From: Tilly Whishaw [REDACTED]
Sent: 28 October 2021 11:33
To: Tim Townsend [REDACTED]
Subject: RE: BN/119/21 - Angels Nursery, Yapton Road, Barnham

From: Tim Townsend [REDACTED]
Sent: 26 October 2021 10:34
To: Tilly Whishaw [REDACTED]
Cc: Chris Pratt [REDACTED]
Subject: BN/119/21 - Angels Nursery, Yapton Road, Barnham

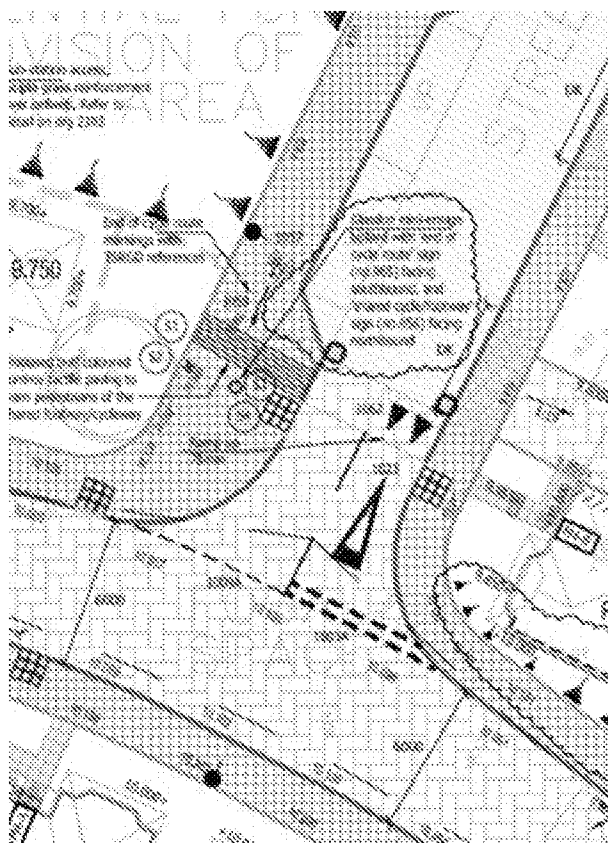
The only apparent outstanding point seems to be with the tie-in point of the cycle/footway as shown below (extract from plan showing how you currently propose things) and as such, I thought it maybe more expedient to approach you directly to try to resolve things:

As shown, it will be particularly difficult for a cyclist to enter or leave the road without overriding the corduroy paving, the tactile paving and part of the ramp. To rectify this would require the corduroy and tactiles being moved southwards and markings provided on the path and – if possible and agreeable with our S38 engineer - on the road away from the ramp. On earlier versions of the internal layout the entry and exit point for the path was further west around the corner and away from conflict points so this might be another option for you/your engineers to consider.

I'd be grateful if you would look into this and provide me with an amended arrangement as soon as possible, please.

Thanks for your email on this. I believe that Chris also discussed this directly with Stephen at Gyoury Self who has sent through the attached updated drawing. Could you confirm that this is now acceptable?
